Station Hill North Site. RBC Energy Comments.

This document summaries the comments received for the 192032/HYB - Station Hill - North Site - ENERGY STRATEGY.

Figure 1

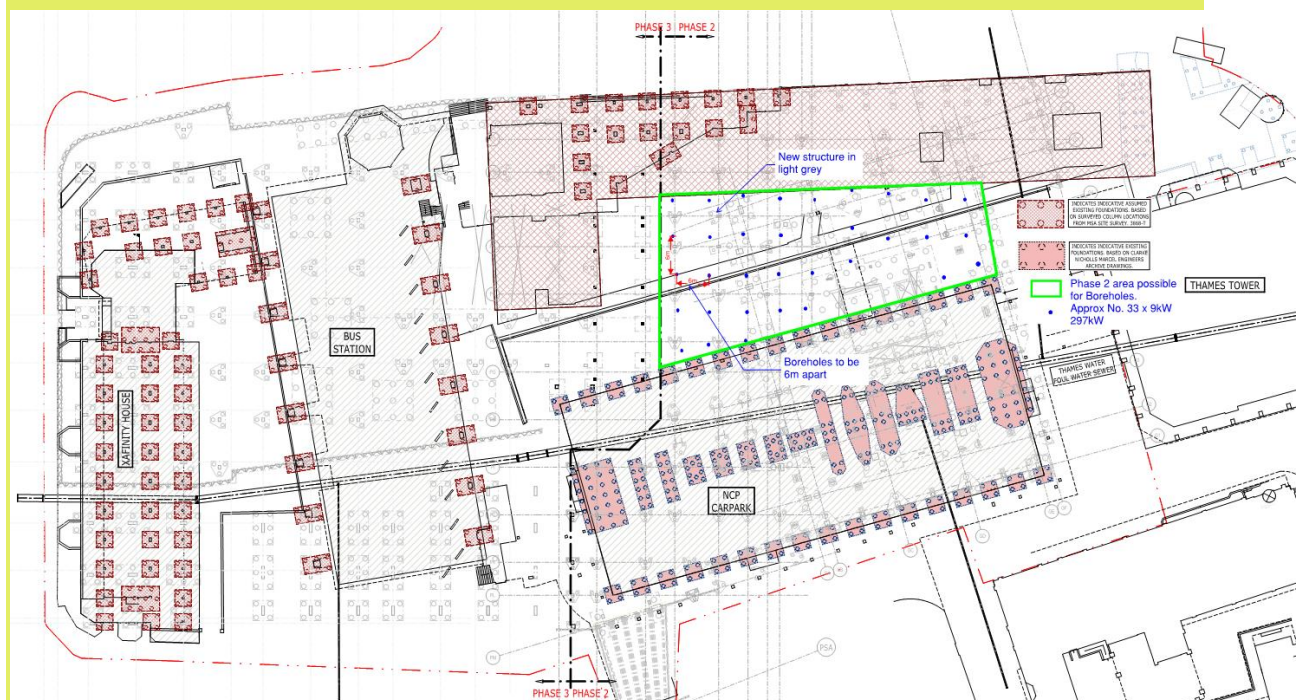
1. Comment Received; The applicant needs to provide further evidence why GSHP, which would normally be expected to result in better carbon reductions, has been omitted in Phase 2 (and not confirmed in Phase 3). This evidence may be in the form of, for example, detailed spatial analysis of GSHP plant and boreholes in relation to the wider Station Hill Phase 2/3 sites. This should be more detailed evidence than that which was provided in the planning application's energy statement.

Coordinated studies have been carried out to review the possibility of using GSHP closed loop system.

The drawing indicated below (See figure 1) highlights the extent of existing foundations and utilities such as the Thames Water sewer on site, the majority of which cannot be removed, considering that a minimum distance of 6m between each borehole is required this will limit the space where boreholes can be located. The space in green indicates the available area that could potentially be used, this works out at approximately 33No. boreholes. If the boreholes were 150m deep, it should be possible to extract 9kW per borehole, this gives approximately 300kW maximum capacity from the GSHP network. This only provides 10% of the overall required load for the building, making this option not viable for the scheme.

The first image is of the building with a cooling demand 75% and heating demand 25%. The image shows some waste heat is still rejected to atmosphere.

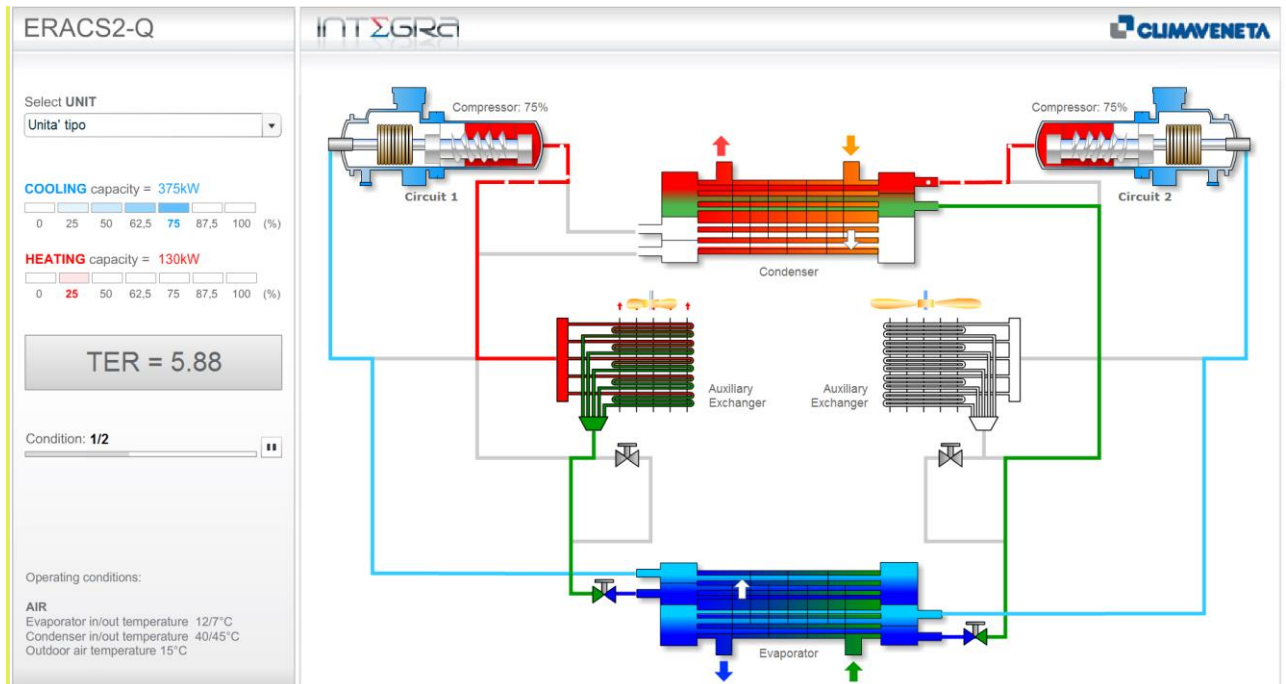
3. Comment Received; GSHP systems are generally more efficient than ASHPs. The Applicant should provide evidence to quantify the extent to which simultaneous heating/cooling demand may in fact result in similar annual efficiencies as has been suggested.

HL Response: We have looked at the energy comparison between GSHP systems compared to ASHPs. In general, a low temperature heating only GSHP would typically achieve a COP of 5, for a system that is providing both heating and cooling this would typically achieve a COP of 4. The ASHP that will be used for station hill phase 2 recovers waste heat when there is a simultaneous heating and cooling demand, therefore the Seasonal Energy Efficiency Ratio (SEER) for the proposed ASHP is 4.24. The ASHP proposed are more energy efficient when used to produce chilled water and LTHW at the same time, as the waste heat can be used to help provide heating and/or cooling.

When there is a requirement for heating and cooling at the same time, then instead of rejecting waste heat/coolth to atmosphere it can be used as shown in images below.
